Bank Street Park
Blackwattle Bay / Tjerruing

Access Report (Philip Chun)

PROPOSED BANK STREET PARK 1A-19 BANK STREET, PYRMONT NSW

Our Ref: AN023-220324_Oculus_Bank St Park_Pyrmont_DRAFT_Access Report_R2_231101
Date: 03 November 2023

Drawing Title Site Plan (Detail)

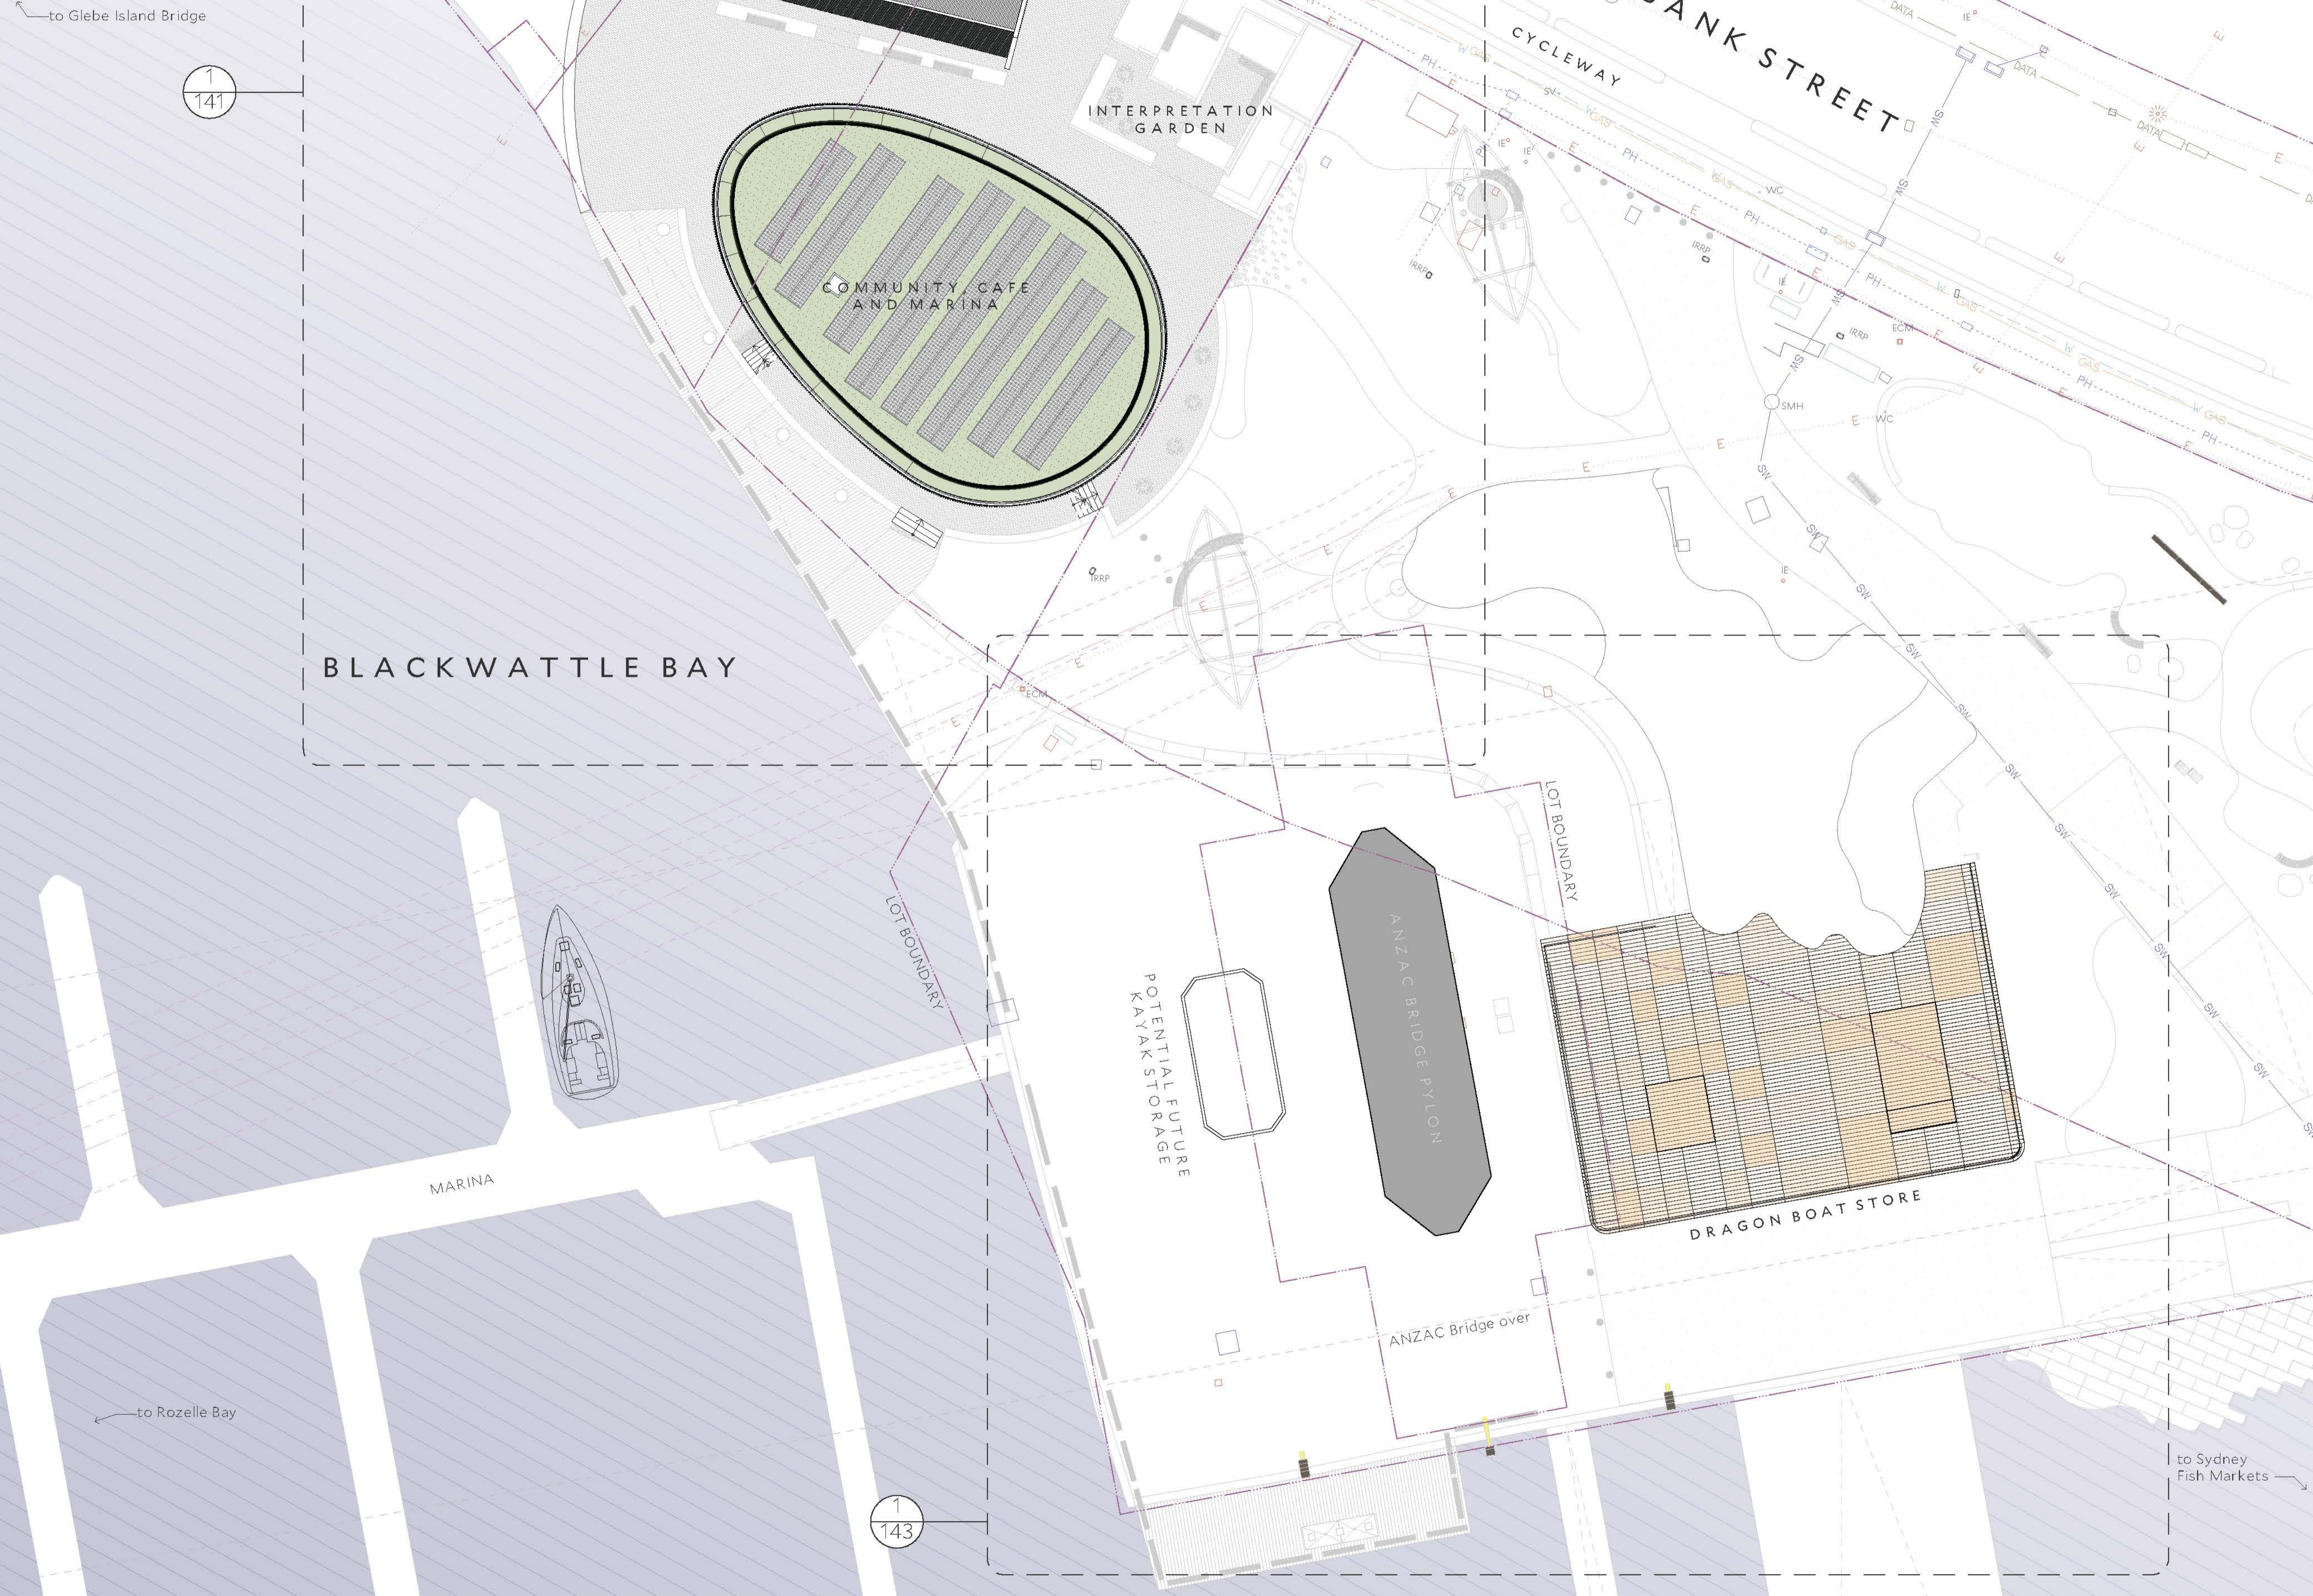
GENERAL NOTE
 A continuous accessible path of travel is to be provided to any building required to be accessible from:
 - The main points of pedestrian entry at the allotment boundary; and
 - From another accessible building connected by a pedestrian link; and
 - From any required accessible car parking space on the allotment.
 (NCC Clause D4D2)

Drawing title	Elevations - 1-3 Bank Street	
Scale	1:100 @ A1	
Date	1/9/23	
Drawn by	TD	
Drawing Number+ Revision	346_SSDA_201	03

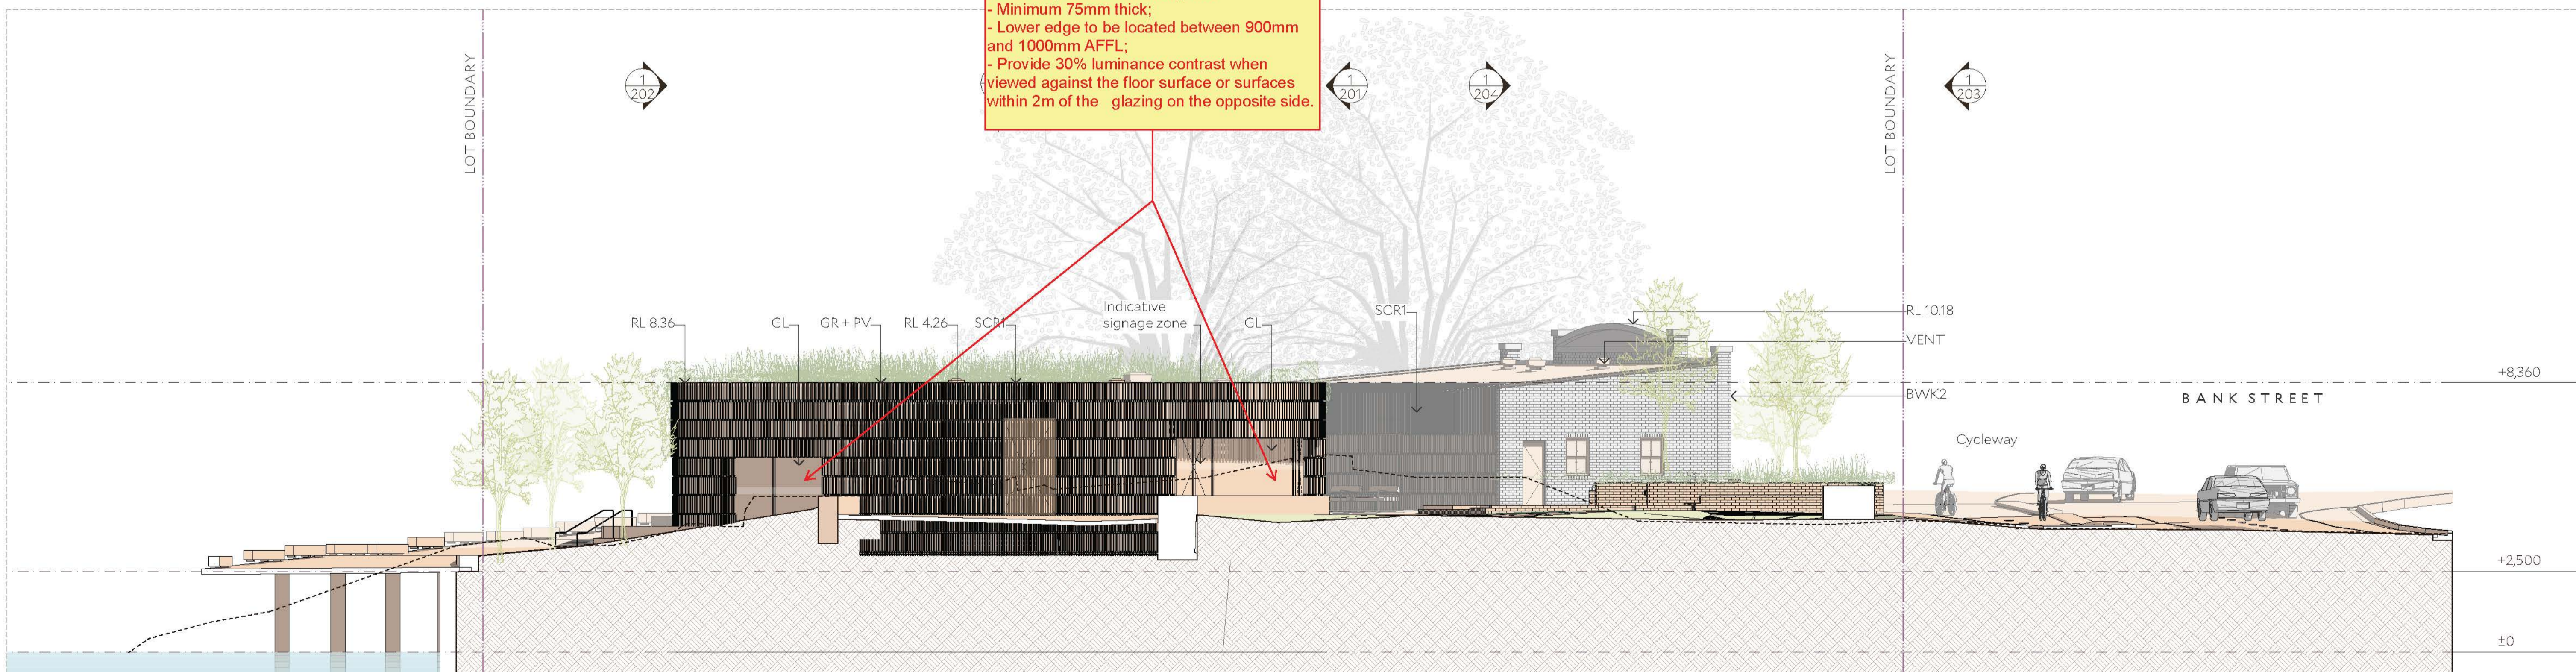
Frameless or fully glazed doorways and sidelights, and any glazing capable of being mistaken for a doorway or opening, shall be clearly marked for their full width, per AS1428.1 (2009), Clause 6.6.

- Visual indication to be a solid, non-transparent, contrasting line;
- Minimum 75mm thick;
- Lower edge to be located between 900mm and 1000mm AFFL;
- Provide 30% luminance contrast when viewed against the floor surface or surfaces within 2m of the glazing on the opposite side.

Drawing title	Elevations - 1-3 Bank Street	
Scale	1:100 @ A1	
Date	21/9/23	
Drawn by	TD	
Drawing Number+ Revision	346_SSDA_202	02

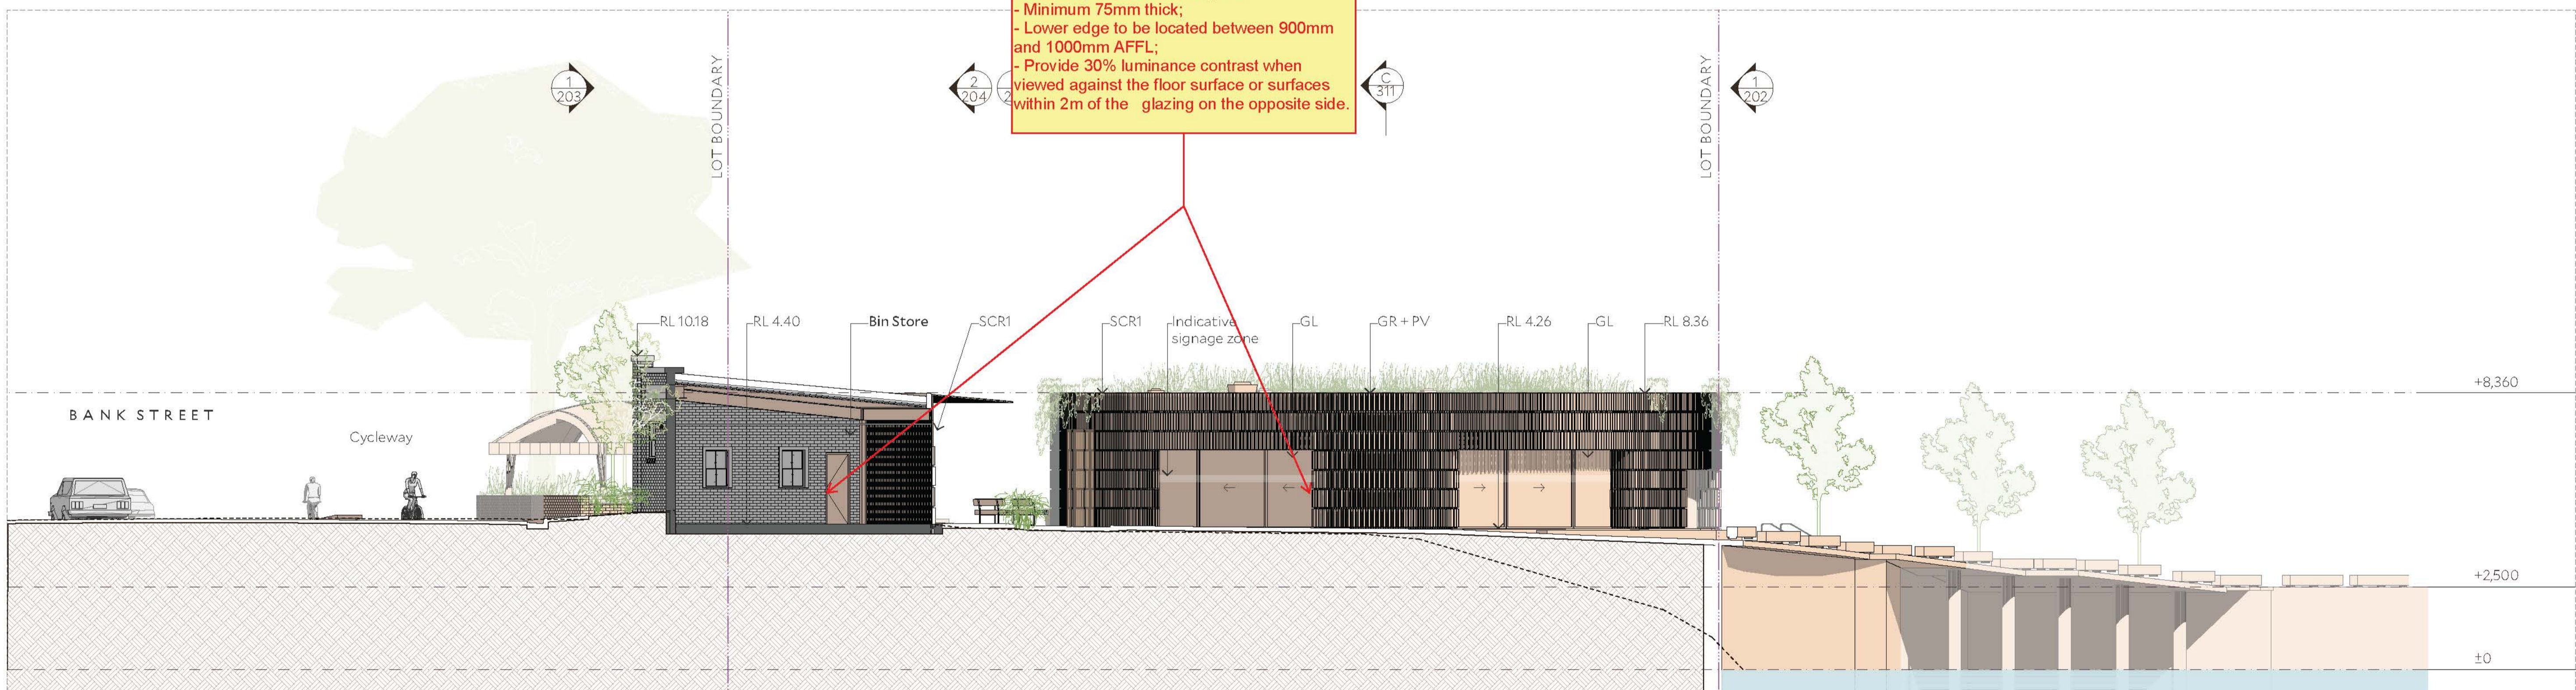
Frameless or fully glazed doorways and sidelights, and any glazing capable of being mistaken for a doorway or opening, shall be clearly marked for their full width, per AS1428.1 (2009), Clause 6.6.

- Visual indication to be a solid, non-transparent, contrasting line;
- Minimum 75mm thick;
- Lower edge to be located between 900mm and 1000mm AFFL;
- Provide 30% luminance contrast when viewed against the floor surface or surfaces within 2m of the glazing on the opposite side.

2 Courtyard (South) Facade
1:100

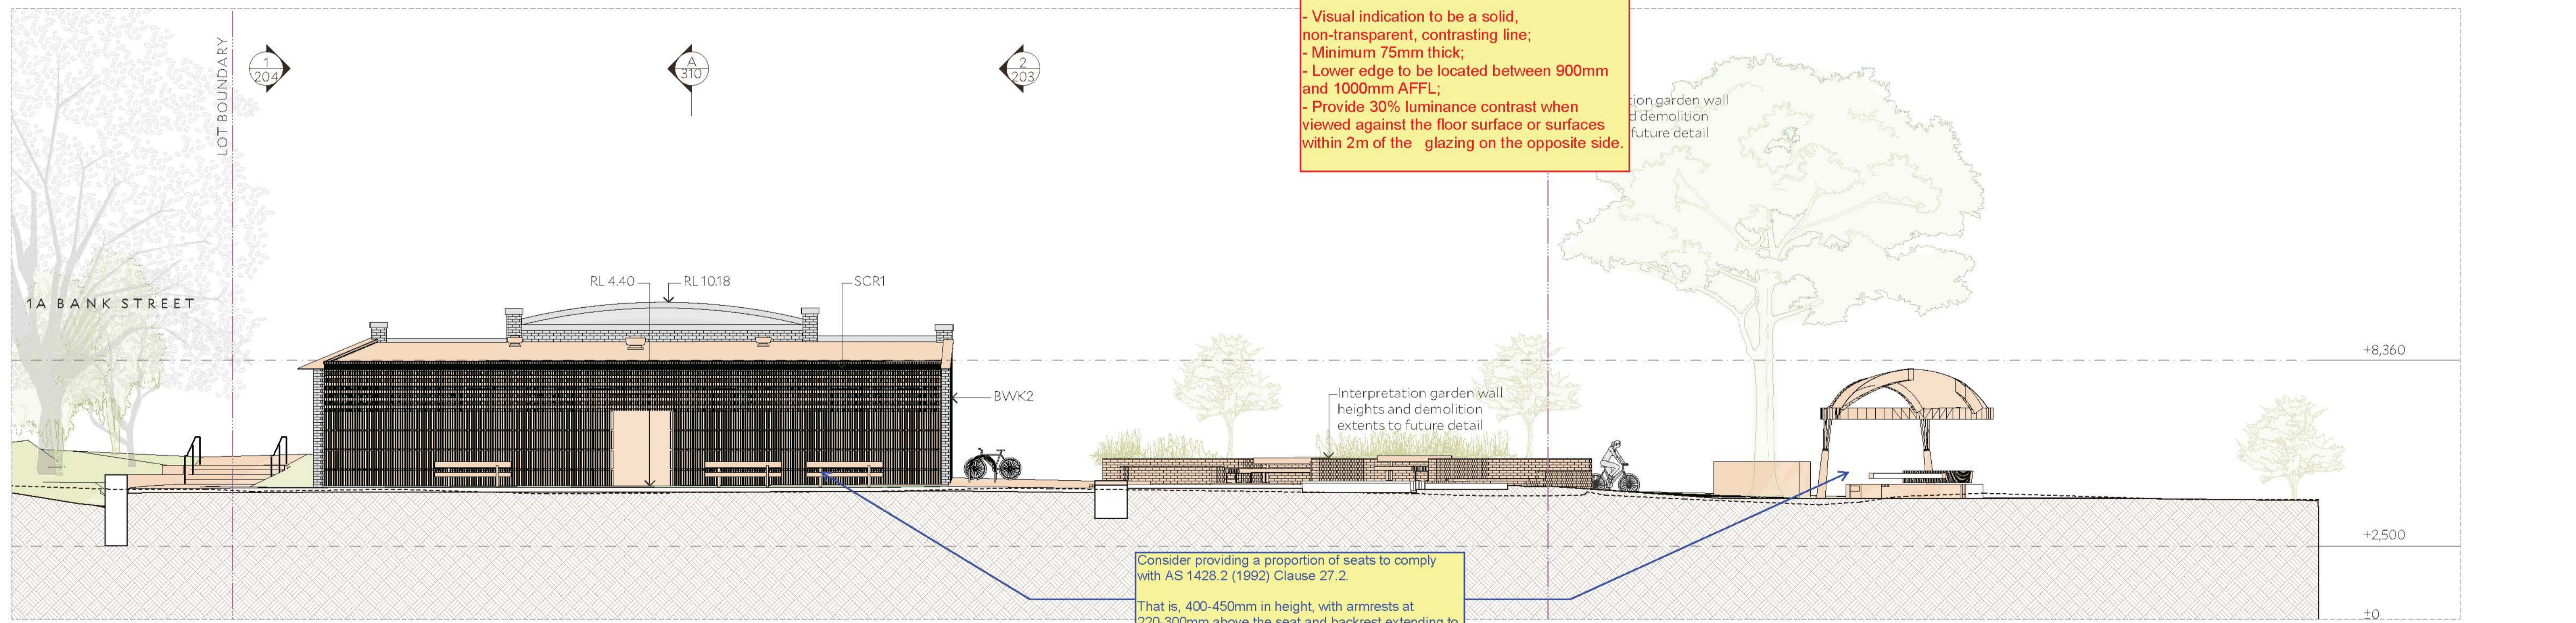
Frameless or fully glazed doorways and sidelights, and any glazing capable of being mistaken for a doorway or opening, shall be clearly marked for their full width, per AS1428.1 (2009), Clause 6.6.

- Visual indication to be a solid, non-transparent, contrasting line;
- Minimum 75mm thick;
- Lower edge to be located between 900mm and 1000mm AFFL;
- Provide 30% luminance contrast when viewed against the floor surface or surfaces within 2m of the glazing on the opposite side.

1 Pylon (West) Facade
1:100

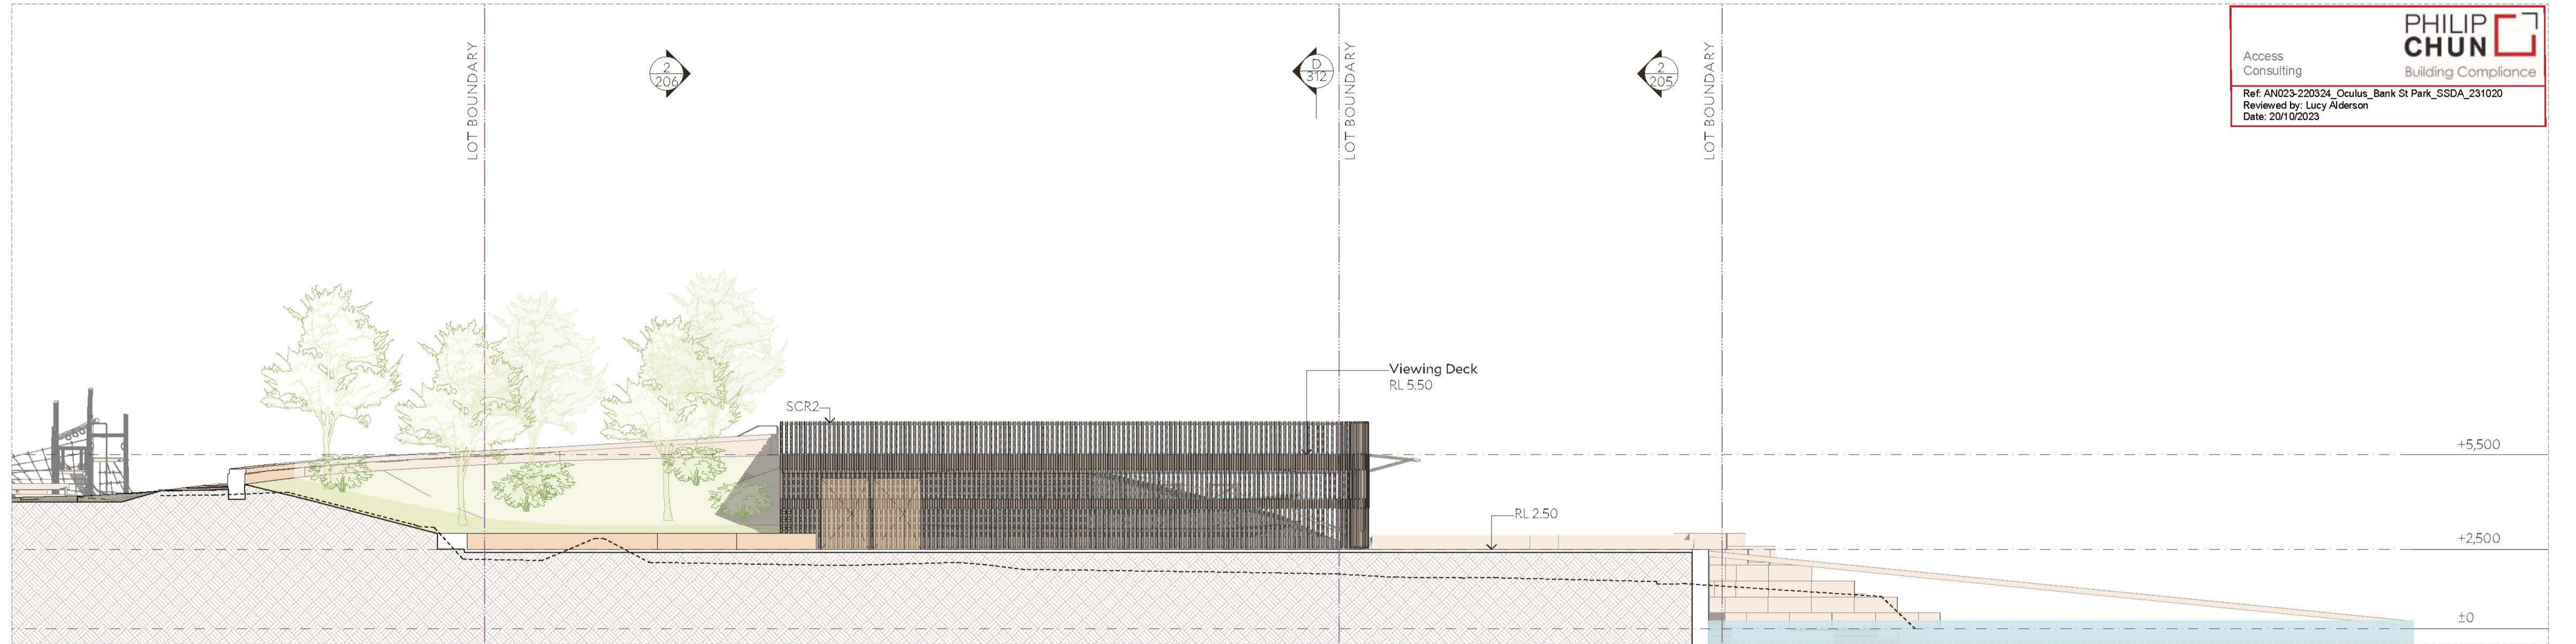
Consider providing a proportion of seats to comply with AS 1428.2 (1992) Clause 27.2.
 That is, 400-450mm in height, with armrests at 220-300mm above the seat and backrest extending to a height of 750-790mm.
